## Waterford/Cristal-Flo Sand Systems (Pre-2009)

FIGURE 13 (as originally manufactured)

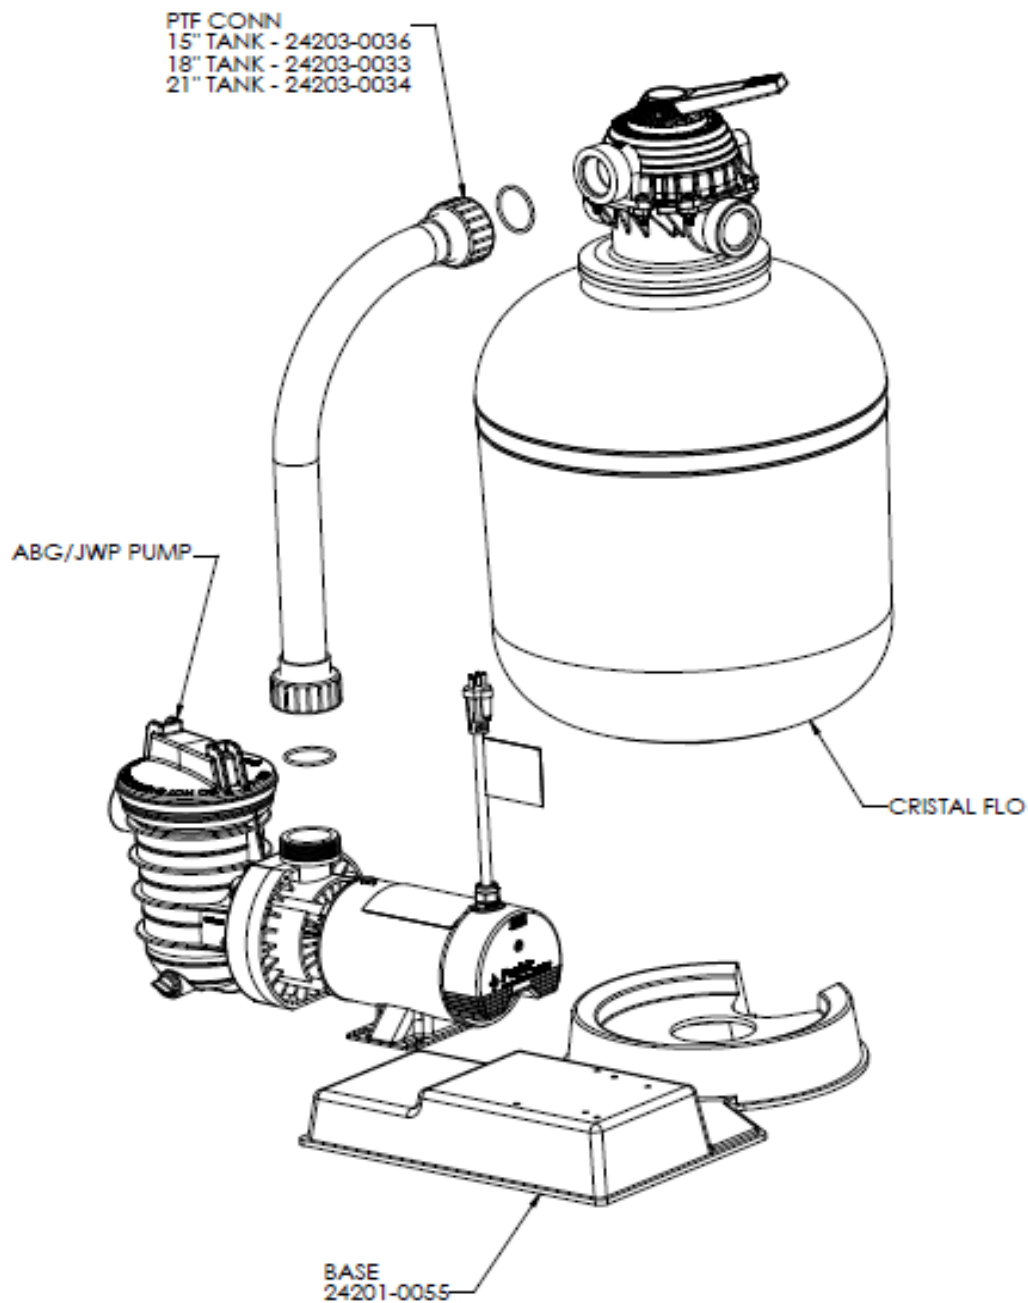
Original systems manufactured as detailed in Figure 13. When replacing the ABG/JWP pump with the corresponding Sta-Rite Dynamo or OptiFlo pump you will also need to order PTF connection part number 155764. This connection includes a union on the valve end and can be cut to length on the pump end biased of the filter size. The fitting and clap are included with the PTF connection. See Figure 14.
